<b>DOCKETED</b>	
<b>Docket Number:</b>	24-OPT-02
<b>Project Title:</b>	Compass Energy Storage Project
<b>TN #:</b>	261144
<b>Document Title:</b>	REV 2 DR VIS-1 Response
<b>Description:</b>	N/A
<b>Filer:</b>	Erin Phillips
<b>Organization:</b>	Dudek
<b>Submitter Role:</b>	Applicant Consultant
<b>Submission Date:</b>	1/20/2025 4:17:53 PM
<b>Docketed Date:</b>	1/20/2025

**To:** California Energy Commission  
**From:** Compass Energy Storage LLC  
**Subject:** Response to Data Request REV 2 DR VIS-1  
**Date:** January 20, 2025  
**Attachment(s):** Appendix 4.13A, Scenic Resources Within 5 Miles of the Project Site

**REV 2 DR VIS-1.** *Revise Figure 1 in Data Request Response #4, Attachment 6, Appendix 4.13A, to highlight the location of Oso Creek adjacent to the project site. Given the creek's adjacent proximity to the project site, provide a discussion of the visual character and importance of Oso Creek as a scenic, natural feature in the table accompanying Figure 1 in Attachment 6, Appendix 4.13A.*

**FIGURE 1**  
Scenic Resources within Five Miles of the Project Site  
Compass Project

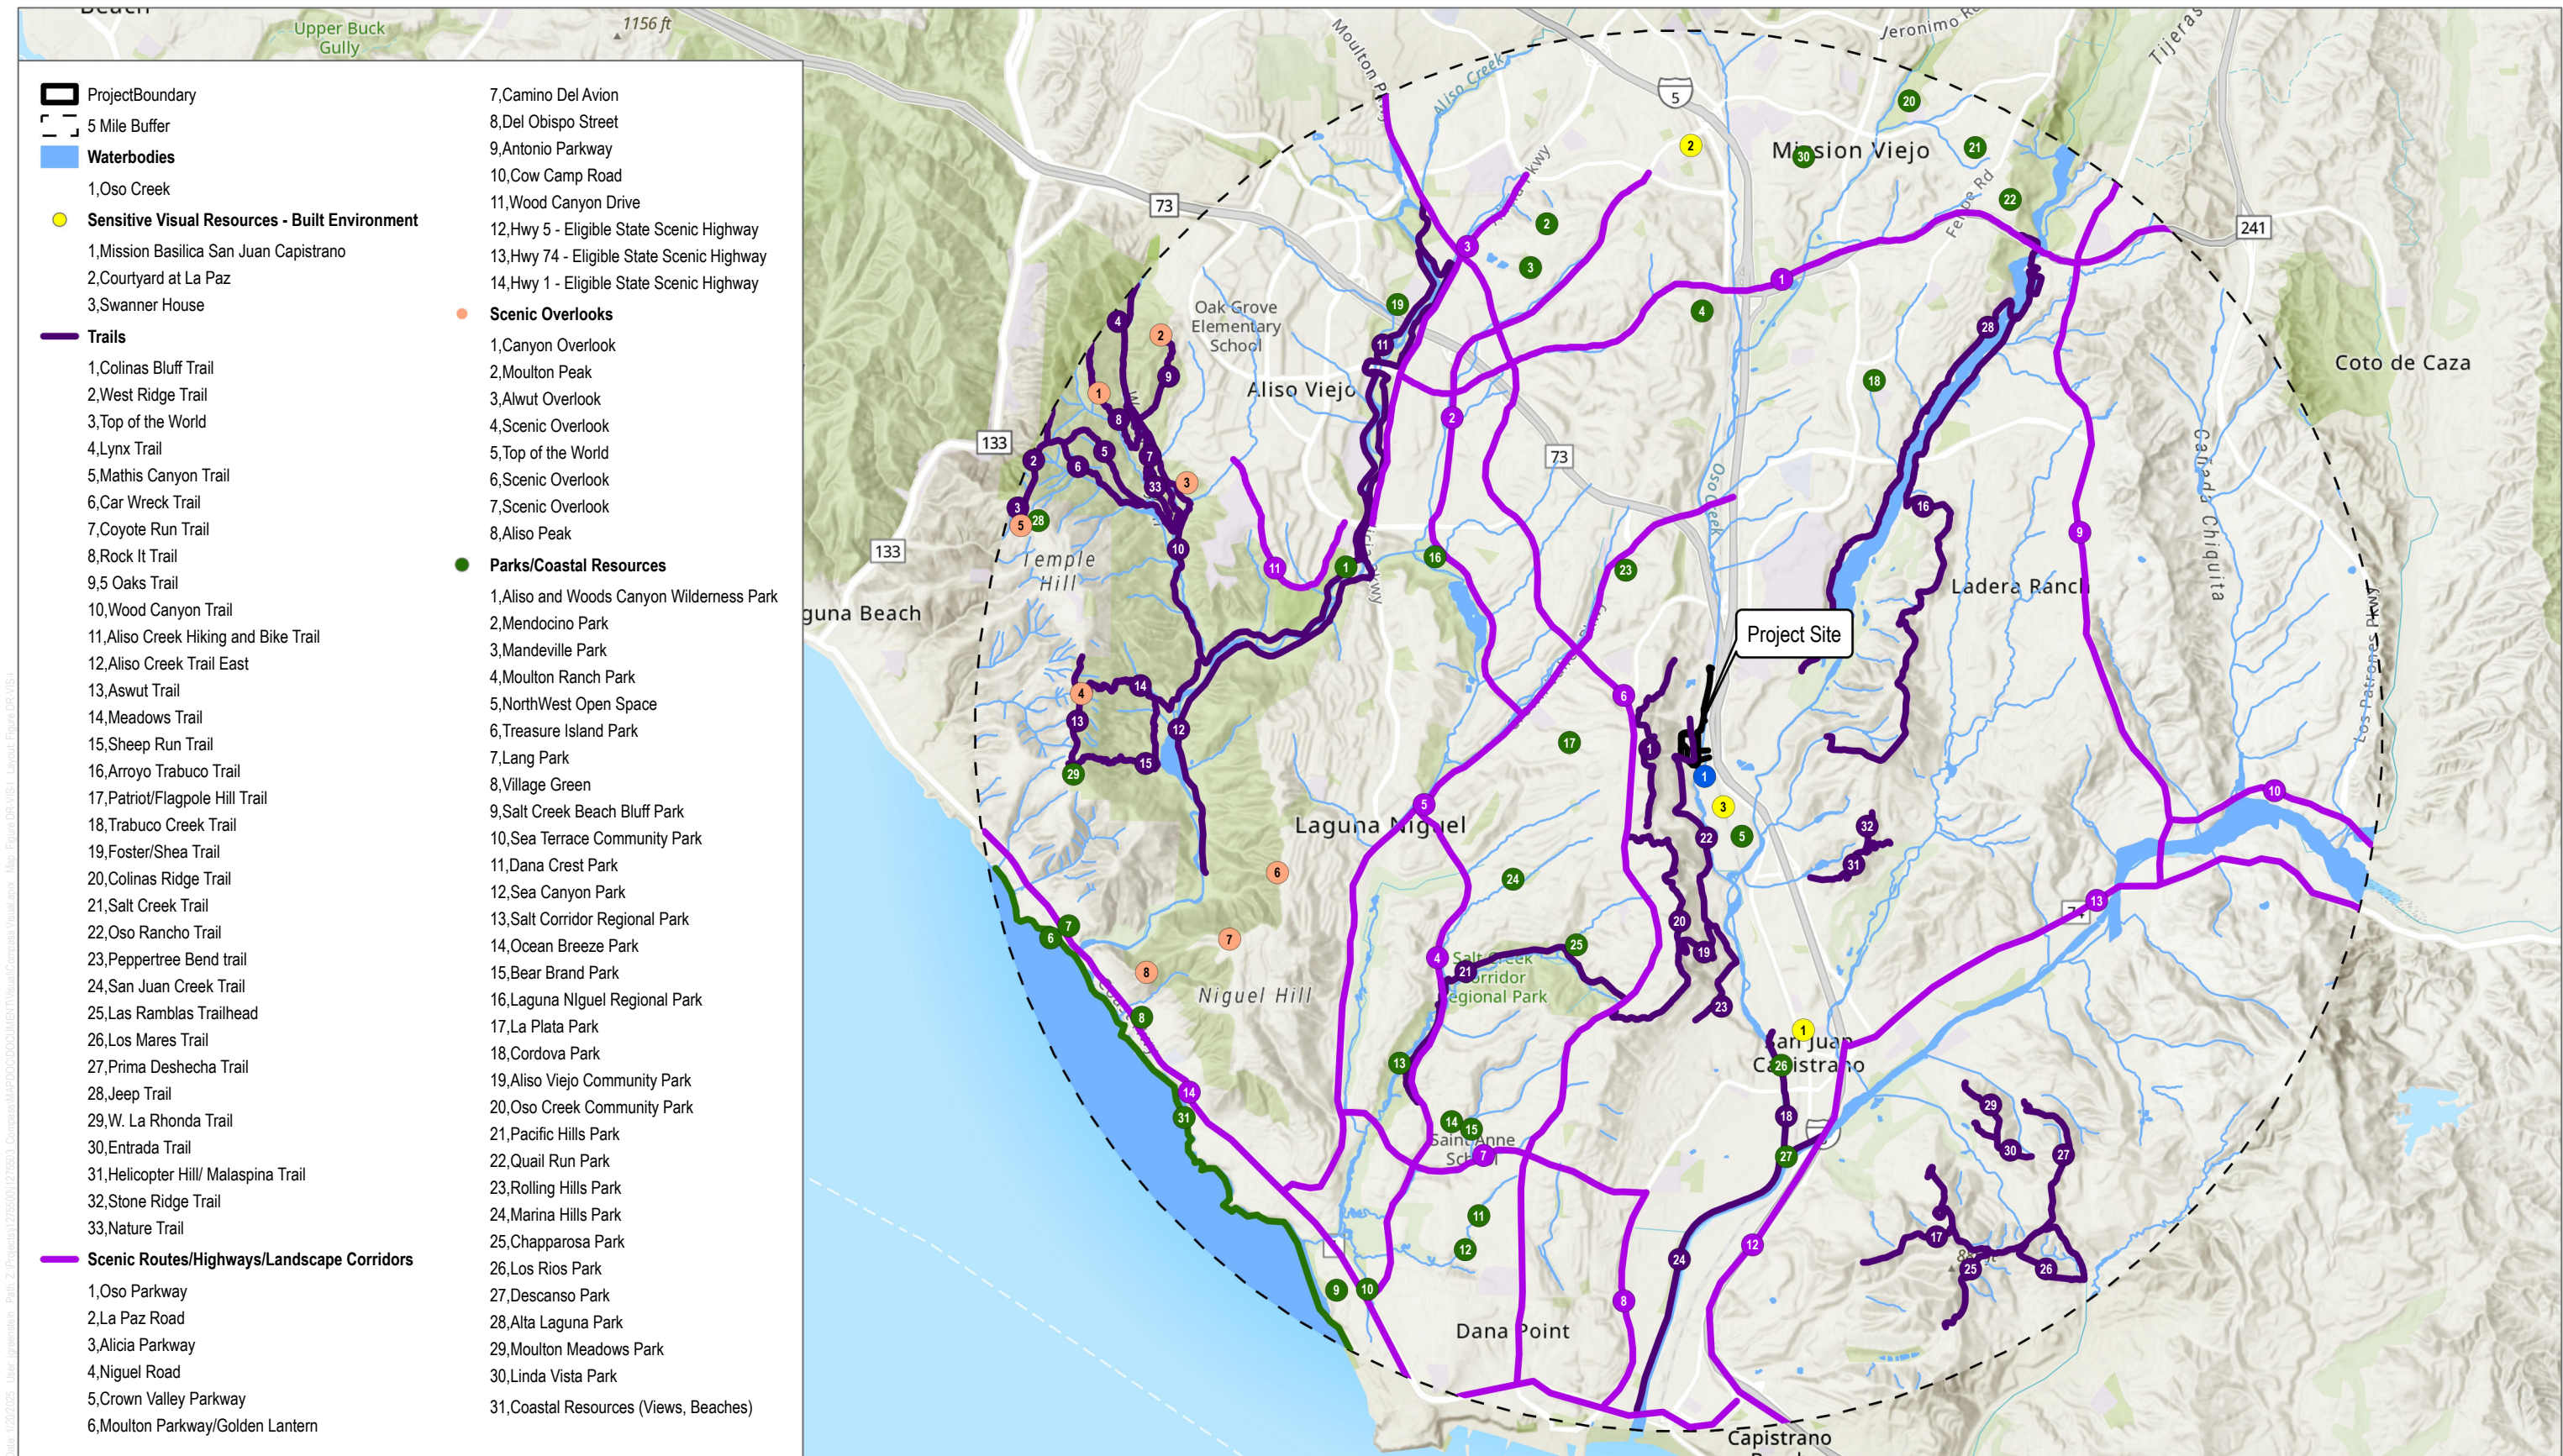
*CEC Siting Regulations (Appendix B [g] [6] [A] [i]) require that scenic vistas and resources within a 5-mile radius of a project be mapped. For the most part, this has been done, though not for the creeks (including Oso Creek). However, given the close proximity of Oso Creek to the project, this important natural feature needs to be highlighted on Figure 1 and addressed in the accompanying table in Attachment 6, Appendix 4.13A.*

The figure and table that comprise Appendix 4.13A have been updated to highlight the location of Oso Creek and provide a discussion of the visual character and importance of Oso Creek as a scenic, natural feature. Please refer to the attachment for the updated version of Appendix 4.13A. Within the figure, Oso Creek has been added to the legend under the 'Waterbodies' heading and is shown on the map as a blue circle. A discussion of Oso Creek is included in the first row of the table.

Scenic Resource	Description (approximate distance from Project site)
<b><u>Waterbodies</u></b>	
1, Oso Creek	<p>Oso Creek originates approximately 7 miles upstream of the City of Mission Viejo in the foothills of the Santa Ana Mountains at an elevation of 1,610 feet. The creek flows south-southeast until its confluence with Trabuco Creek about 2 miles upstream of downtown San Juan Capistrano. Trabuco Creek then flows south for 2 miles until it meets with San Juan Creek which then flows into the Pacific Ocean.</p> <p>Oso Creek channel contains a u-shaped concrete lining that terminates near the northern border of the Project site. Through this area, the creek embankment is about 10 feet in height. After the lined channel ends, Oso Creek transitions to an unlined channel and meanders past the southern Project boundary. This southerly reach is characterized by a creek channel resulting in 30- to 50-foot-high embankments. In addition, the southerly reach of the creek (a segment of which is aligned to the east of the proposed BESS) also features mixed willow cottonwood hardwood riparian habitat, and occasionally, a large rock-strewn creek bottom.</p> <p>Sections of Oso Creek near the Project site are inaccessible to the public, and the nearest public viewpoint (Camino Capistrano) does not provide views of the creek due to the embankments and elevation of the road. Thus, the Project does not interfere with any existing public views of Oso Creek.</p> <p>In light of the above, the visual character and importance of Oso Creek as a scenic, natural feature is insignificant and would not be significantly altered by the Project.</p>
